# *R. C. Tronics Incorporated*

## Add Sequencing RCT-00498 To Ambulance Power Center RCT-743

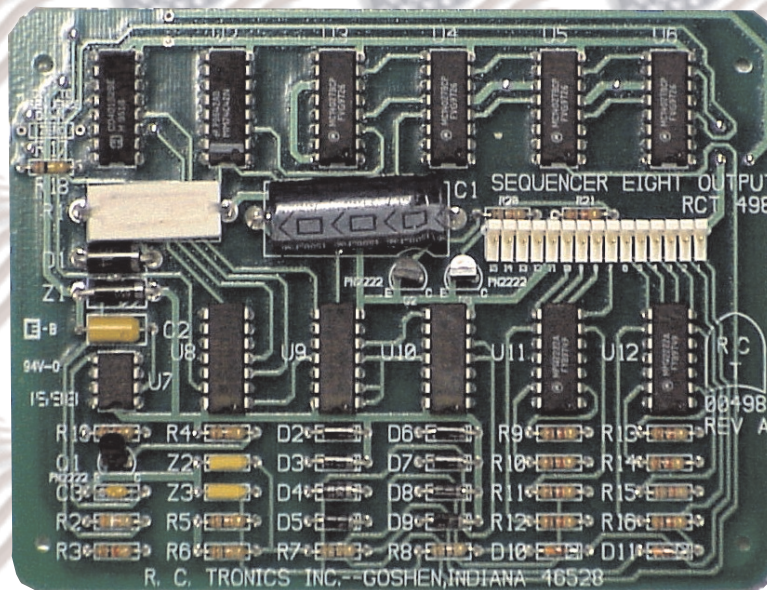
*Remove Dash Switch PCB. Verify that it is RCT-745, Revision C.*

*Remove Resistors R20-21-22-23-24-25 and R26 on RCT-745.*

RCT-498 Sequencer mounts to the rear of the RCT-745 switch PCB. Feed data cable thru opening. With 4 each Key-1894 Standoff and eight 4-40 x 3/8 machine screws mount the sequencer to switch PCB. Be careful, not to pinch the wiring of data cable. This clearance is tight.

**Remove R17 to Sequence Down.**
